ISSUE/REVISION:		
REV.	DATE	DESCRIPTION
1	10/03/2023	ISSUED FOR BID
1	10/18/2023	ADDENDUM 1

PROJECT:
GUARANTEED RATE FIELD -
FIRE ALARM REPLACEMENT

DRAWING TITLE:
ELECTRICAL FIRE ALARM NEW
WORK PLAN - SERVICE LEVEL
- SECTION 6

DRAWING TITLE:
ELECTRICAL FIRE ALARM NEW
WORK PLAN - 300 LEVEL -
SECTION 6

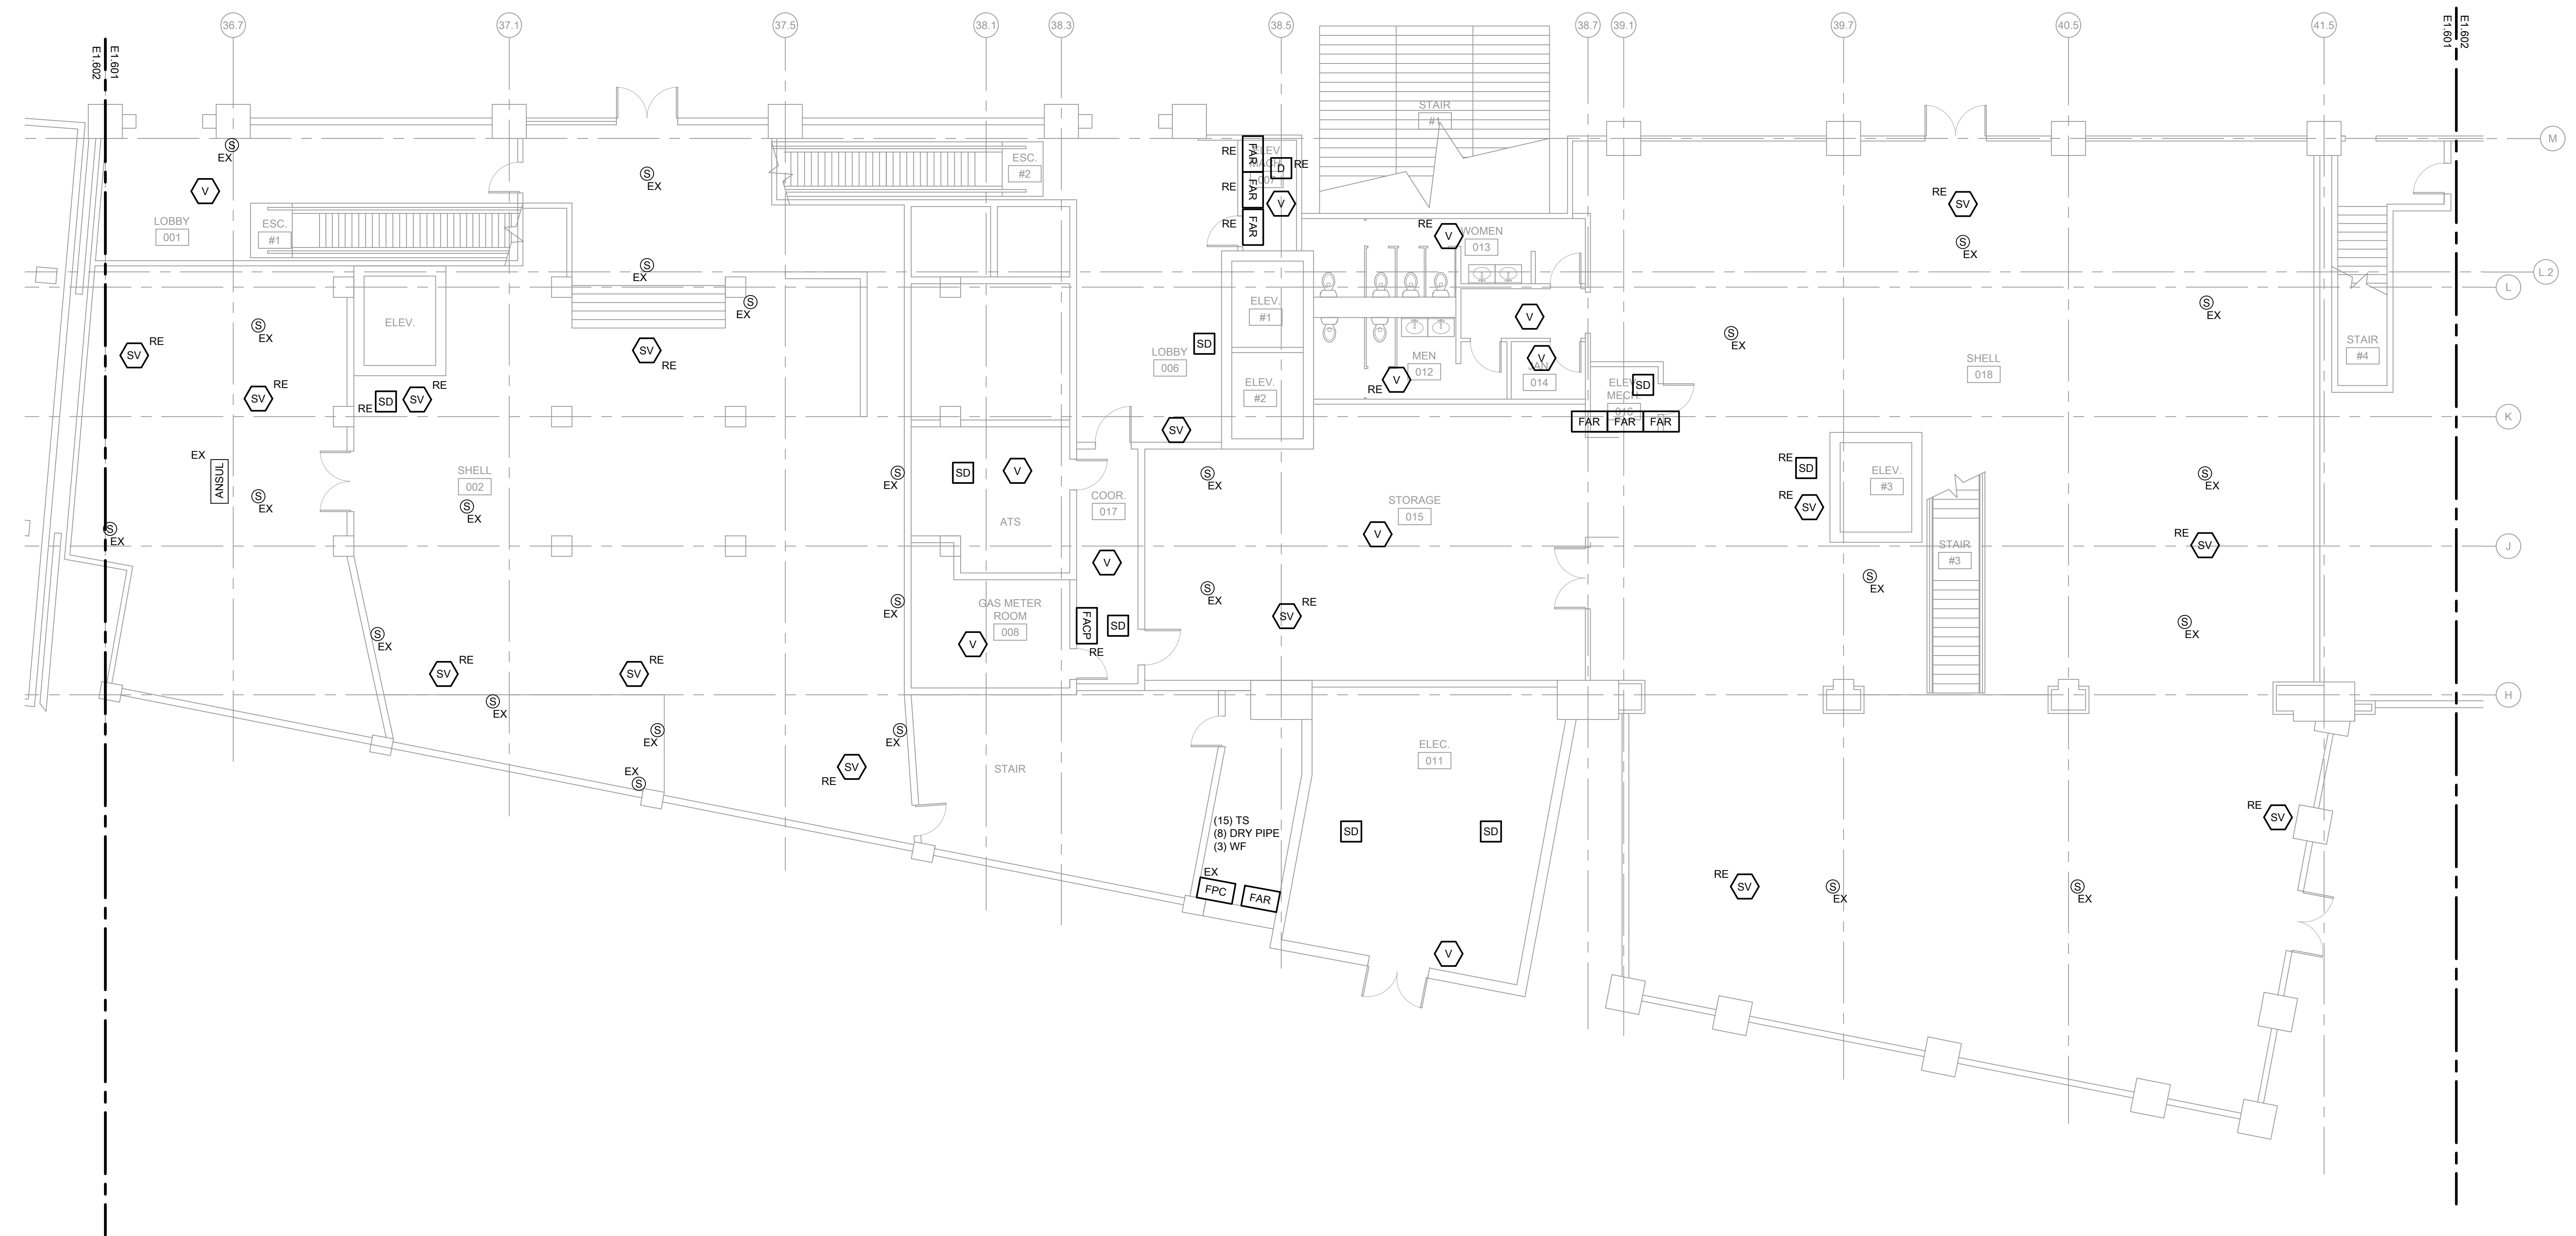
A2. ALTERNATE 2: FURNISH AND INSTALL WEATHER PROOF VISUAL FIRE ALARM DEVICE. FURNISH AND INSTALL NEW WIRING AND CONDUIT AS REQUIRED. CONTRACTOR TO DETERMINE BEST MOUNTING LOCATION BASED ON FIELD CONDITIONS.

1 ELECTRICAL FIRE ALARM NEW WORK PLAN - PLAZA LEVEL - 320 W 35TH - SECTION 1

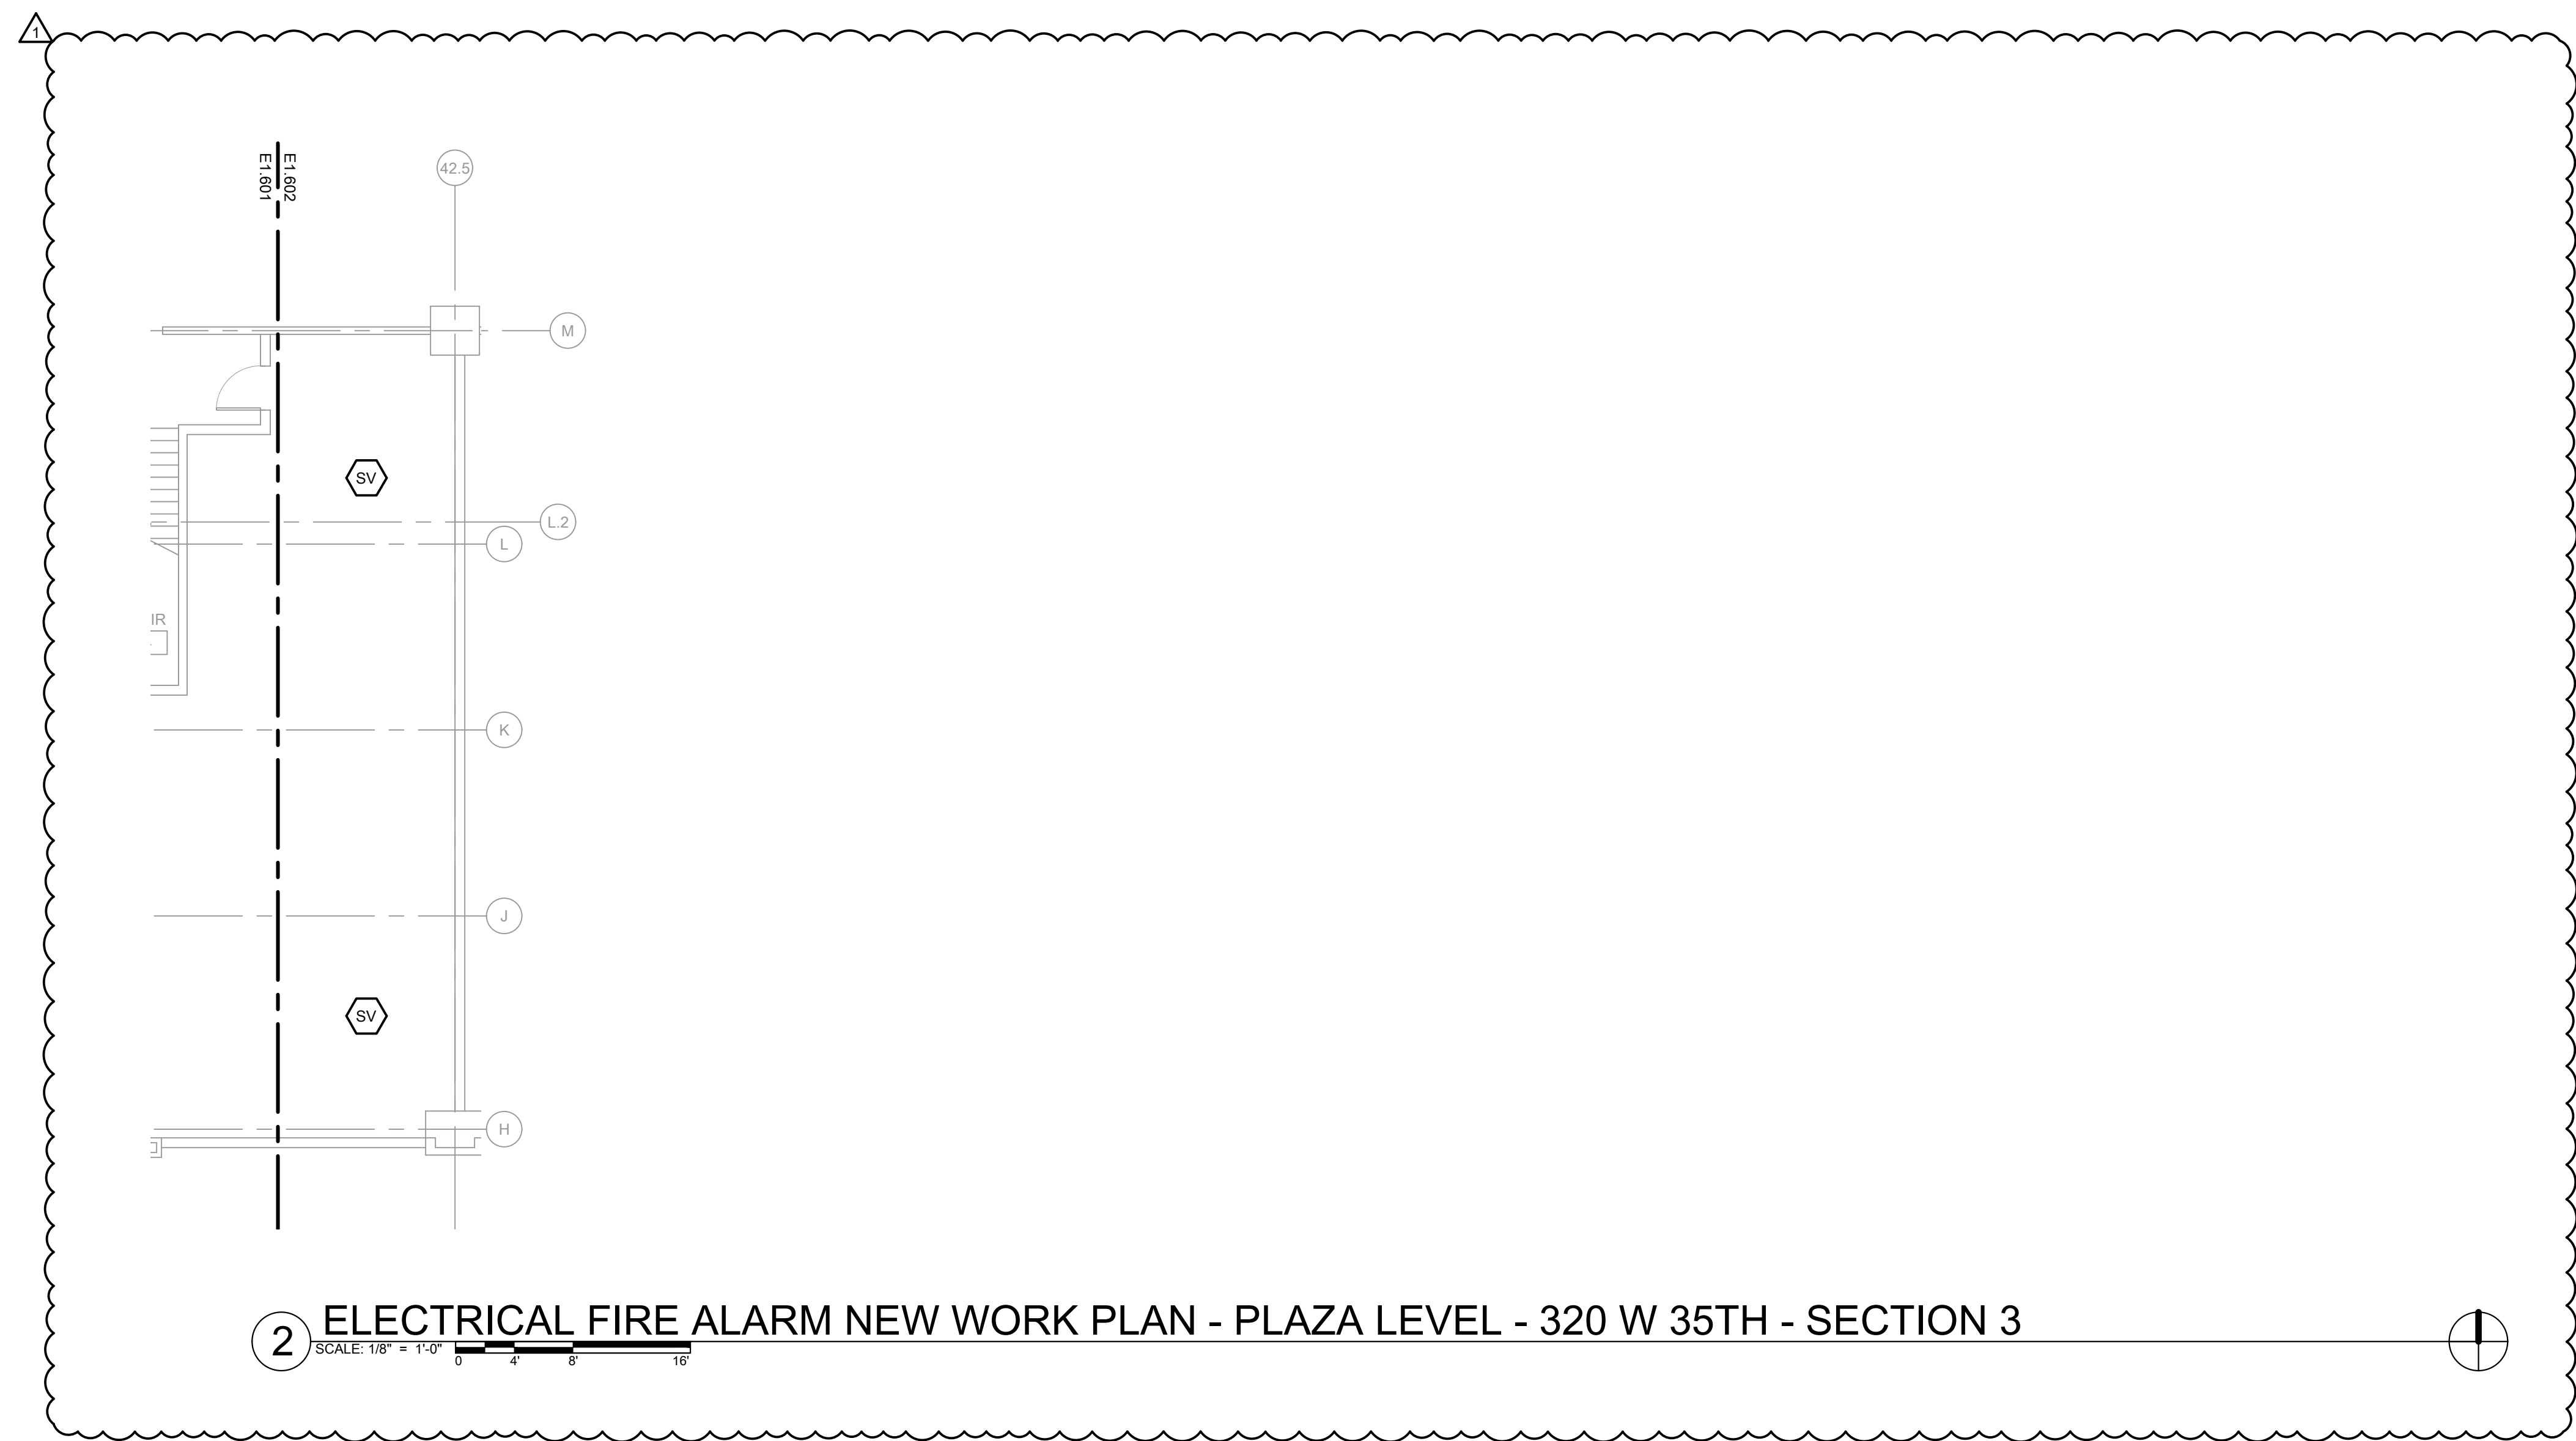
A2. ALTERNATE 2: FURNISH AND INSTALL WEATHER PROOF VISUAL FIRE ALARM DEVICE. FURNISH AND INSTALL NEW WIRING AND CONDUIT AS REQUIRED. CONTRACTOR TO DETERMINE BEST MOUNTING LOCATION BASED ON FIELD CONDITIONS.

ELECTRICAL FIRE ALARM NEW WORK PLAN - MEZZANINE LEVEL - 320 W 35TH - SECTION 1

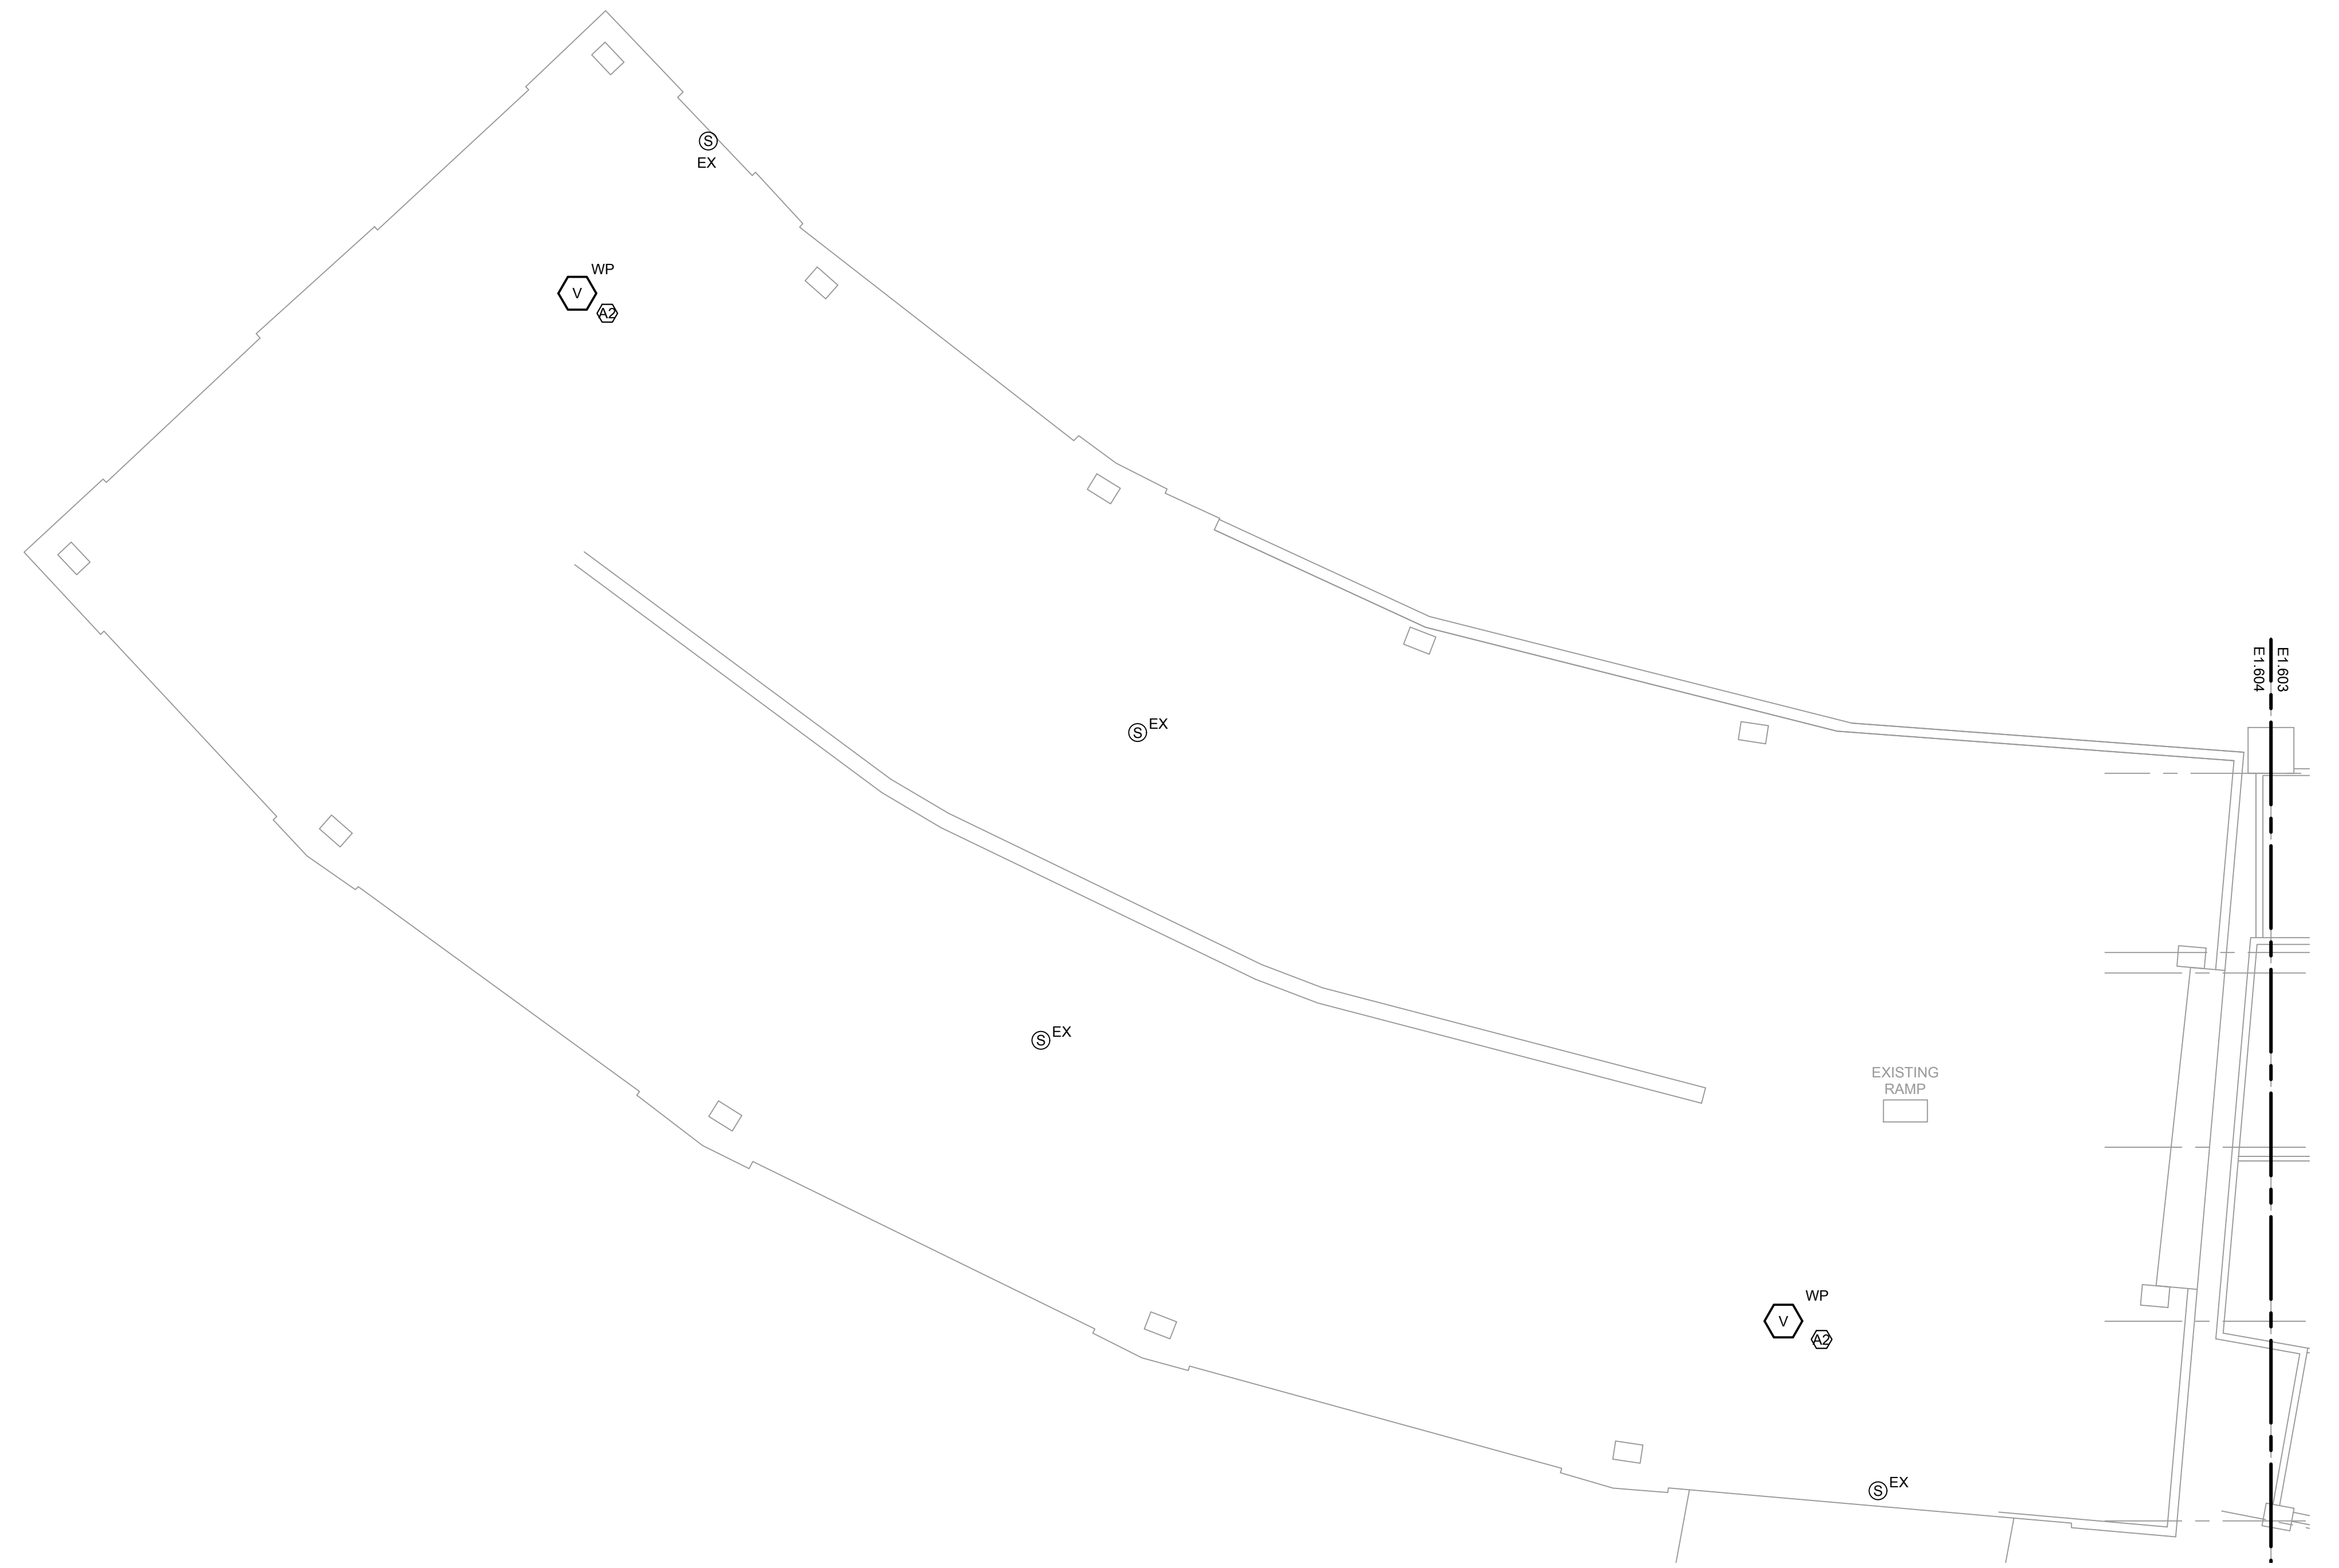
A2. ALTERNATE 2: FURNISH AND INSTALL WEATHER PROOF VISUAL FIRE ALARM DEVICE. FURNISH AND INSTALL NEW WIRING AND CONDUIT AS REQUIRED. CONTRACTOR TO DETERMINE BEST MOUNTING LOCATION BASED ON FIELD CONDITIONS.
